SUBJECT: Transmittal of Revised Responses to AP1000 DSER Open Items

AP1000 Design Certification Review  
Draft Safety Evaluation Report Open Item Non-Proprietary Responses

**DSER Open Item Number:** 3.8.2.1-1 Revision 2

**DSER Open Item Number:** 19.1.10.1-5 (Response Revision 2)

Figure A5.3-25

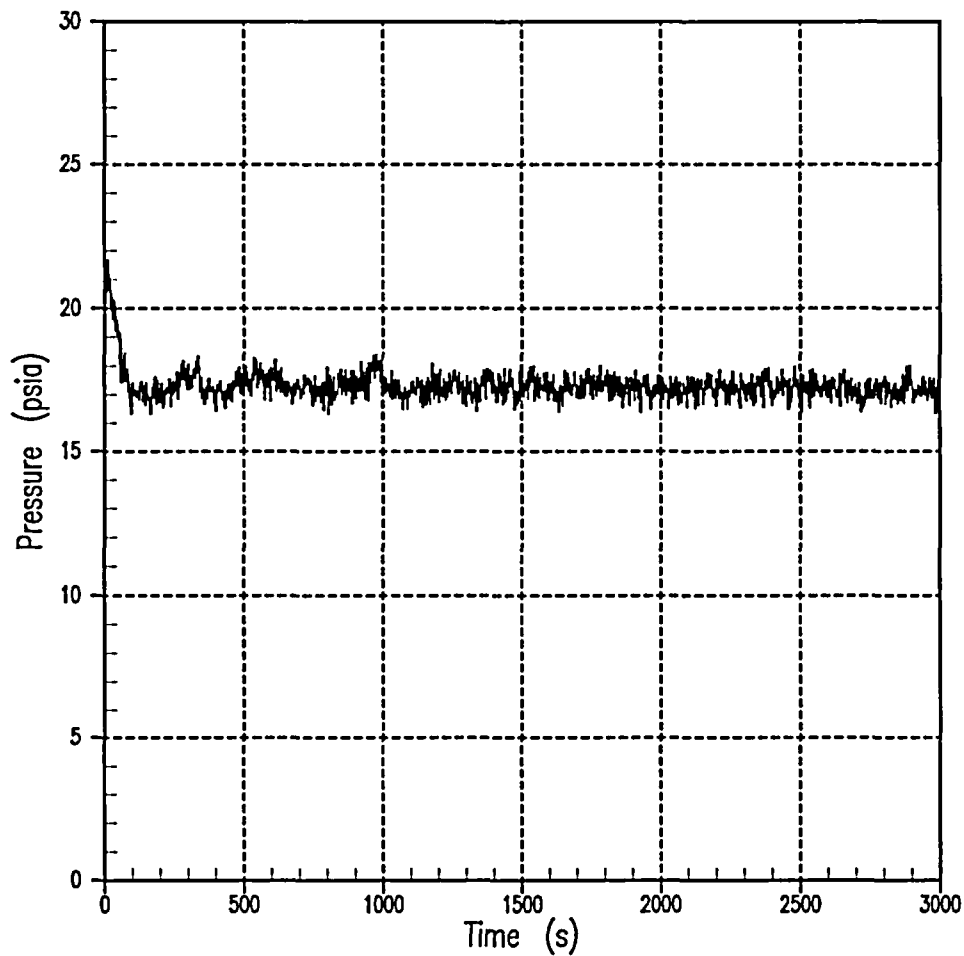
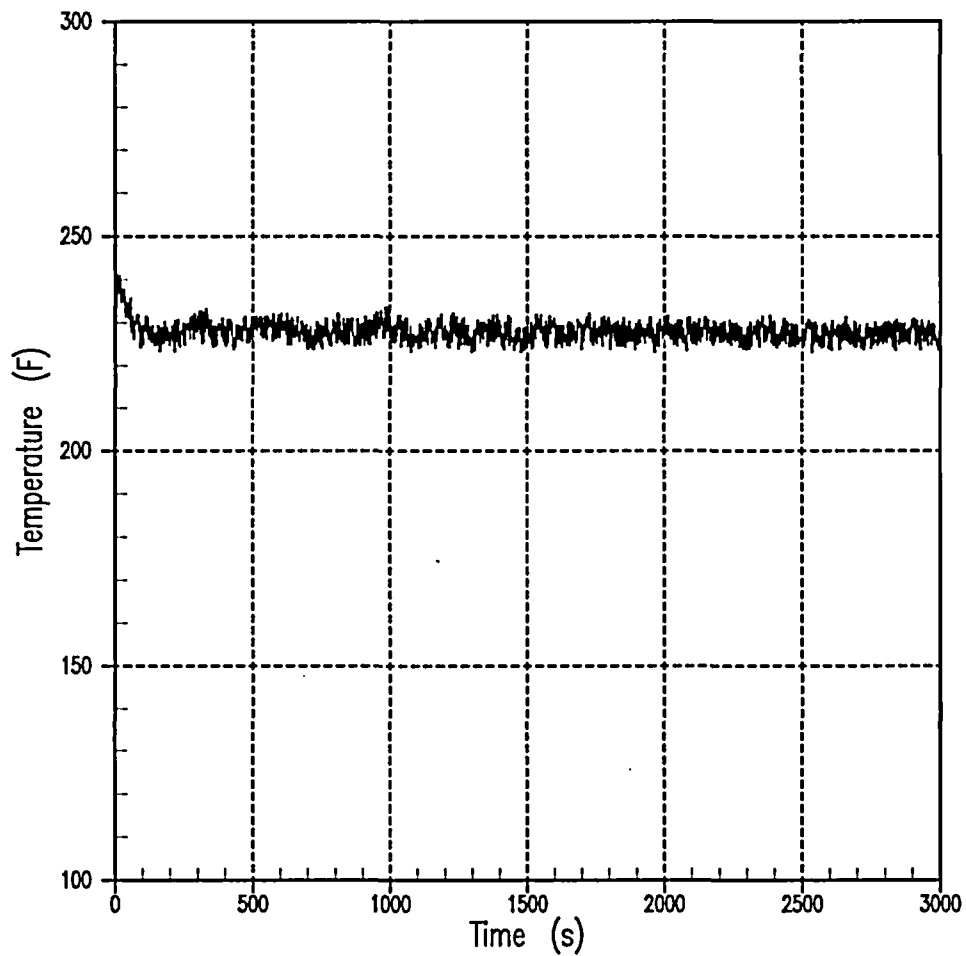
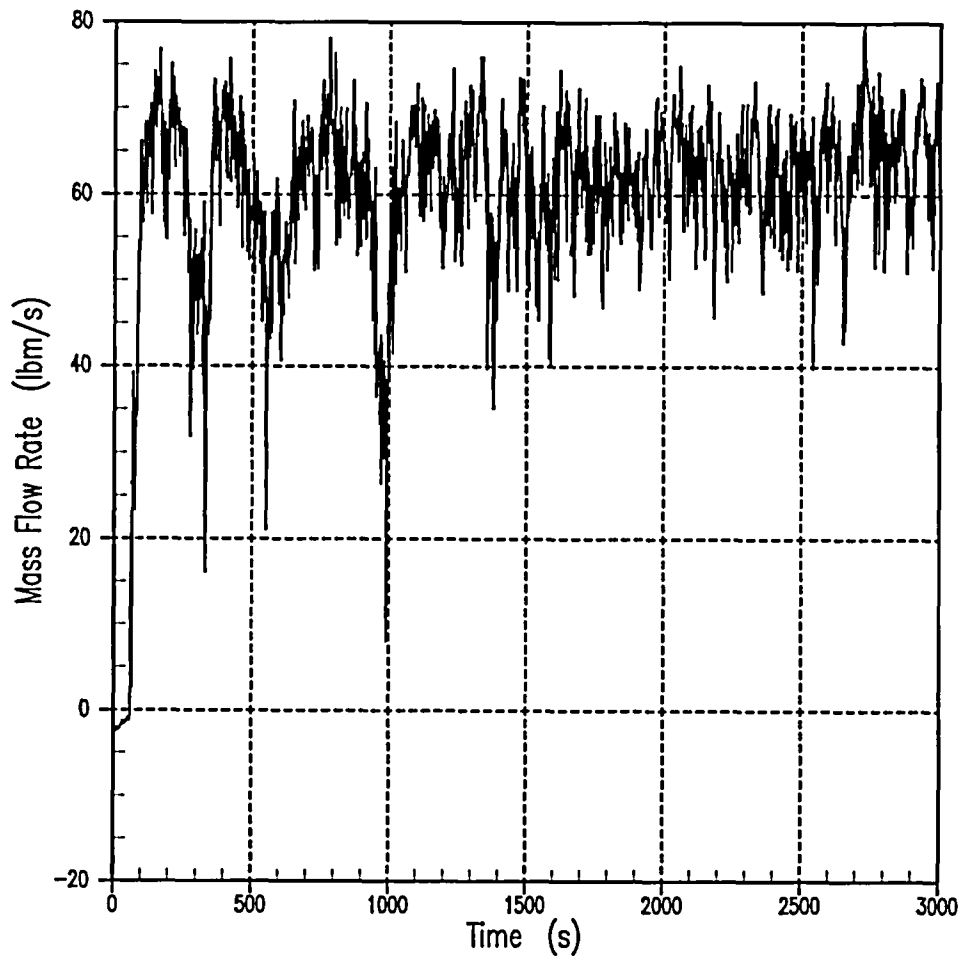
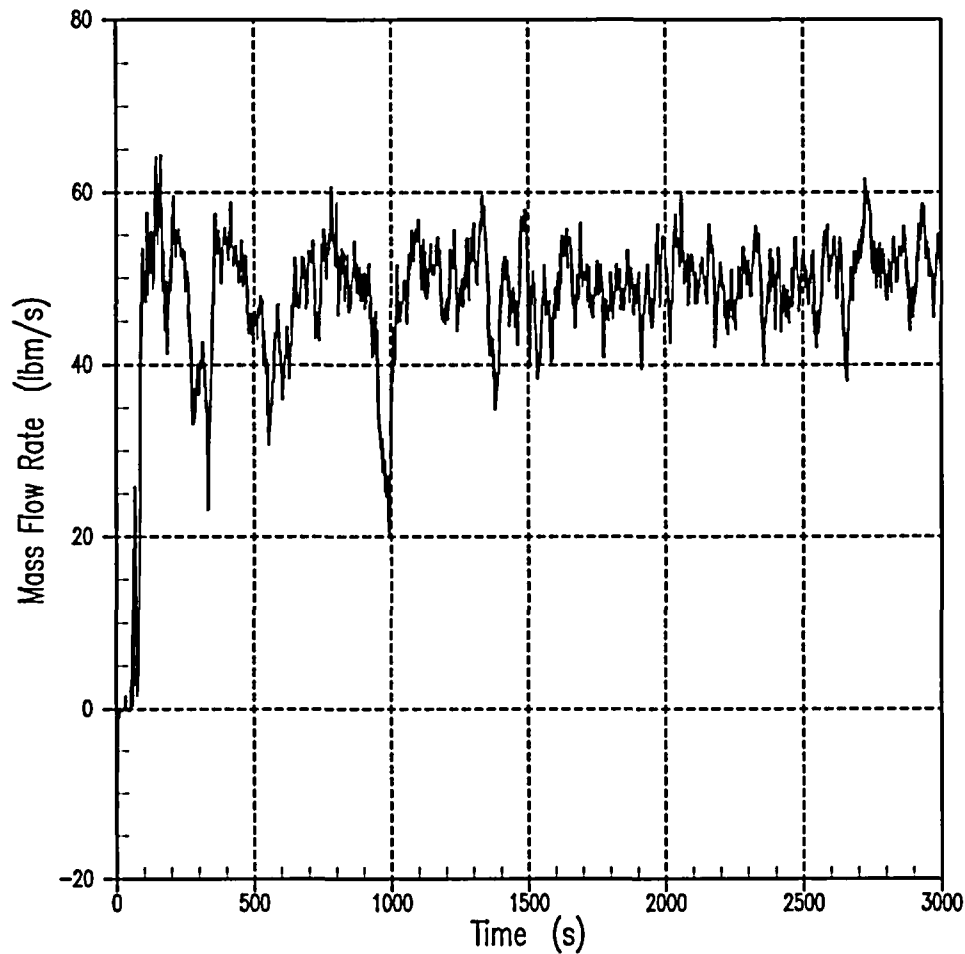
This issue remains open. In the revised response to RAI 720.013, Westinghouse performed long term cooling analyses for bounding conditions in the PRA. (Case F DEDVI, 1 CMT, 1 recirc line, 3/4 ADS4 and CI) and (Case G DEDVI, 1 CMT, 1 recirc line, 4/4 ADS4 and CI failure). The WCOBRA/TRAC code was used for LTC calculations with input conditions derived from MAAP4 analyses. As discussed in the DSER the staff has not reviewed MAAP4 except for its use in screening studies. These are analyses using minimum equipment sets as discussed in the DSER. The staff believes that only a methodology the staff has reviewed should be utilized. In addition, as a result of staff and ACRS questions, the WCOBRA/TRAC long term cooling model has been changed. The staff believes that the revised model should be used in these bounding calculations.

Initially, the only injection comes from the IRWST into the reactor vessel through the intact DVI injection line (Figure A5.3-28). Since at the beginning of the analysis, the level in the PXS-B room is below the DVI injection nozzle elevation, only steam from the downcomer is vented out through the break. Water starts to flow back into the downcomer through the broken DVI line about 2 hours into the transient. This is the time when the level has about reached its minimum value in containment, yet decay heat is still relatively high in the PXS-B room becomes high enough to provide sufficient driving head for this to happen. This time, unlike the Case F DVI break scenario, the transition into reversed injection of water through the break into the downcomer occurs a little earlier, and is somewhat softer. As a result, the increased depressurization rate observed in Case F does not occur. Still, the levels in the downcomer (Figure A5.3-15), the reactor core (Figure A5.3-16) and the upper plenum (Figure A5.3-22) are maintained high enough by the available DVI injection to provide acceptable core cooling.

The availability of all ADS Stage 4 valves provides enough venting capacity to assure adequate depressurization and successful performance of the passive safety systems (Figures A5.3-23 and A5.3-24). The fuel remains covered throughout the transient, and adequate core cooling is provided to remove the decay heat. The hot rod cladding temperature at the top of the core is about 20°F above saturation (Figure A5.3-26) and steadily decreasing.

Figure 19.1.10.1-5 R2-1: Cold Water Droplet Size Sensitivity

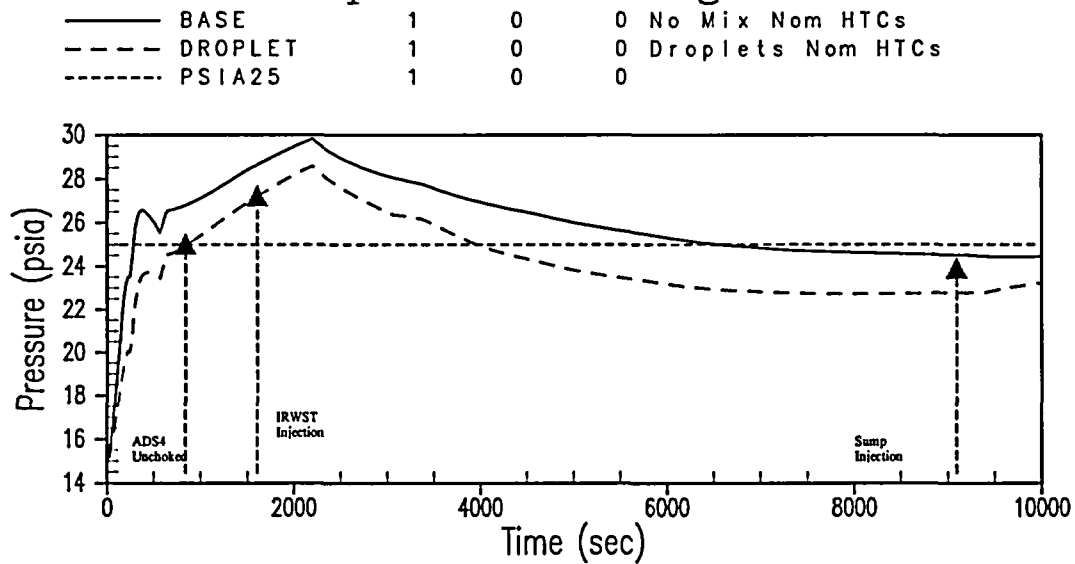
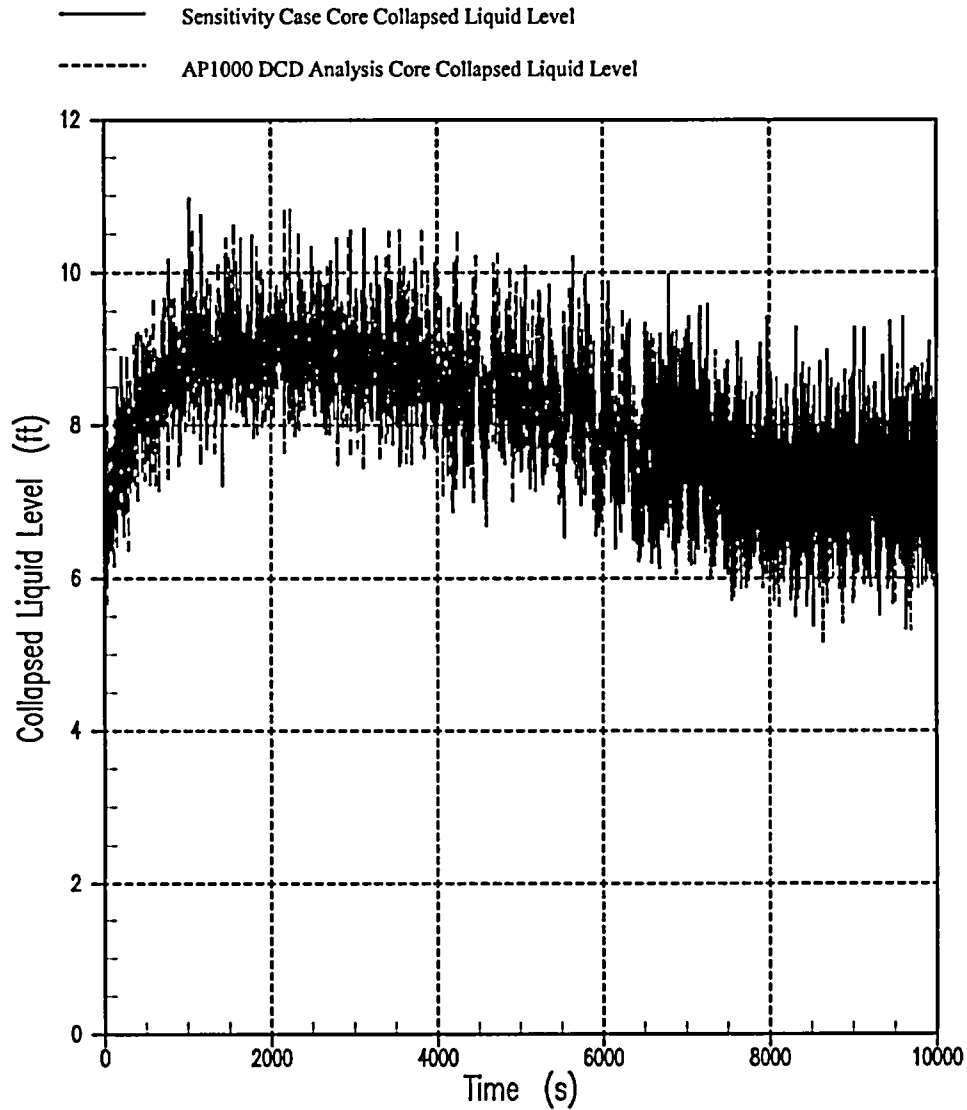
Westinghouse should quantify the effect of lower containment backpressure as indicated in the response to OI 15.2.7-1 Item 7 on long term cooling performance.

In response to DSER Open Item 15.2.7-1 Item 7, a bounding calculation was performed with WGOTHIC to determine a conservative lower bound for the containment backpressure for the DEDVI case. For this analysis, it was assumed that the cold water spilled from the loop side of the DVI would be introduced into the compartment as 100-micron droplets. This assumption assures maximum condensation of steam in the compartment, and the containment pressure for this case was approximately 2 psi lower than the case where the cold water is spilled directly to the floor of the compartment as is shown in Figure 19.1.10.1-5 R2-1. For the NOTRUMP DEDVI case, it was determined that from the time that flow from the ADS-4 valves becomes unchoked until stable IRWST injection becomes established, the containment pressure is always above the assumed backpressure boundary condition of 25 psia. These conclusions formed the response to OI 15.2.7-1 Item 7.

An additional sensitivity study was performed with WCOBRA/TRAC to determine the effect of using this bounding containment backpressure for the AP1000 long-term cooling analysis. The DCD limiting case of a postulated DEDVI break in the PXS "B" Room was reanalyzed using the pressure curve shown in Figure 19.1.10.1-5 R2-1 from the time of sump injection onward. Figure 19.1.10.1-5 R2-2 compares the core collapsed liquid level predictions of the DCD analysis (dashed line) and the sensitivity case (solid line); the time axis of the WCOBRA/TRAC runs has a 2500 second time offset from the WGOTHIC case. In Figure 19.1.10.1-5 R2-2, the sensitivity case exhibits no adverse impact on core cooling relative to the DCD analysis; no cladding temperature excursion is predicted for either analysis. The long term cooling analyses for the DCD and PRA are not sensitive to the slightly lower backpressure indicated by the WGOTHIC bounding analysis.

Figure 19A.2-8-1  
Actual Footprint Modeling

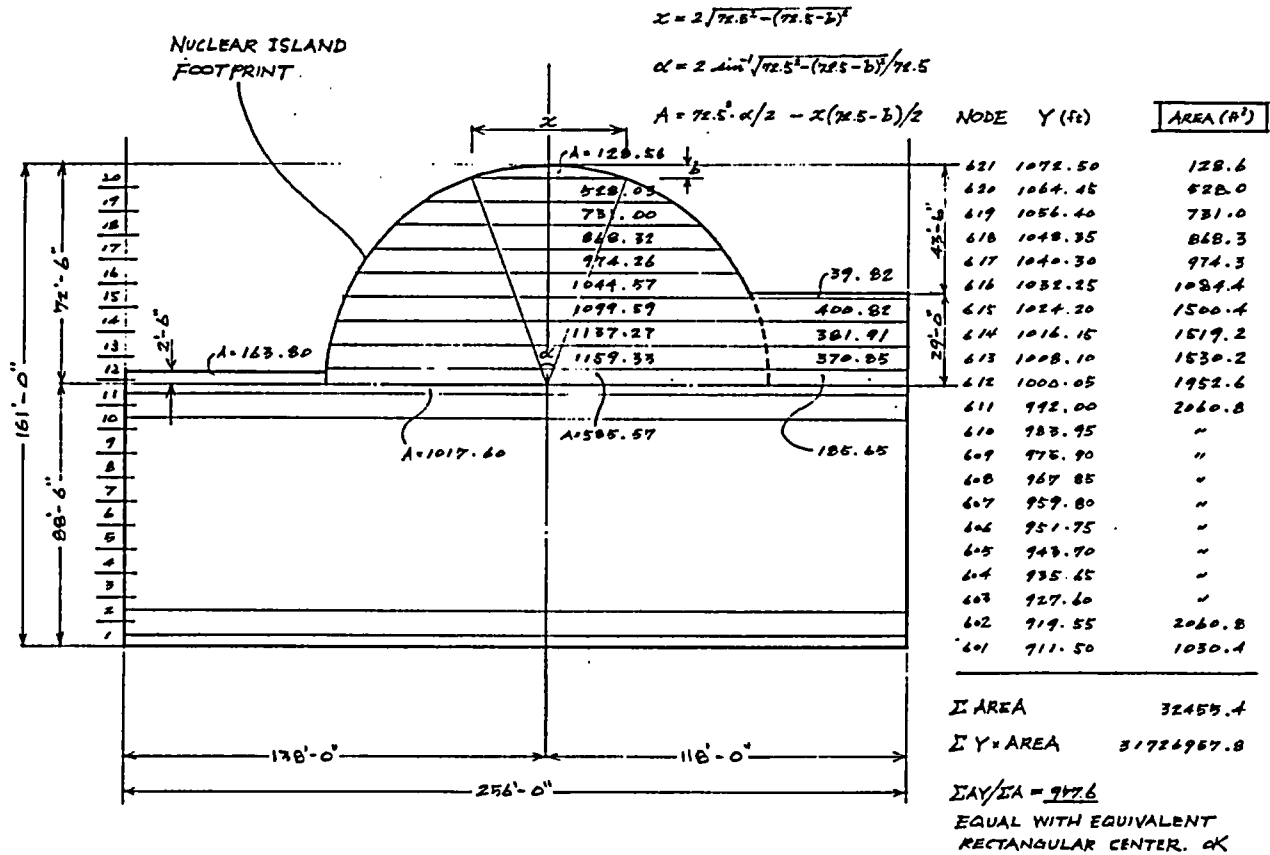
Westinghouse has not adequately justified that the effect of lift off of the nuclear island basemat is not significant in the seismic margin evaluation. The results that are presented in the Revision 1 response may cause the HCLPF values to fall below the review level earthquake of 0.5g. Further, the CIS lift off with the nuclear island basemat uplift may make the seismic response worse. Westinghouse has not presented results from a combined model with liftoff from the CIS and nuclear island basemat to demonstrate that the results are not higher than those presented.

A new model was developed that models more accurately the actual footprint of the basemat. The actual footprint configuration is modeled as shown in Figure 19A.2-8-1. The overall width is 161' whereas the equivalent rectangle only had a width of 140'. Both have the same overturning resistance in linear analyses where soil springs take tension. Both models have the same eccentricity between the center of mass of the nuclear island and the centroid of the basemat.
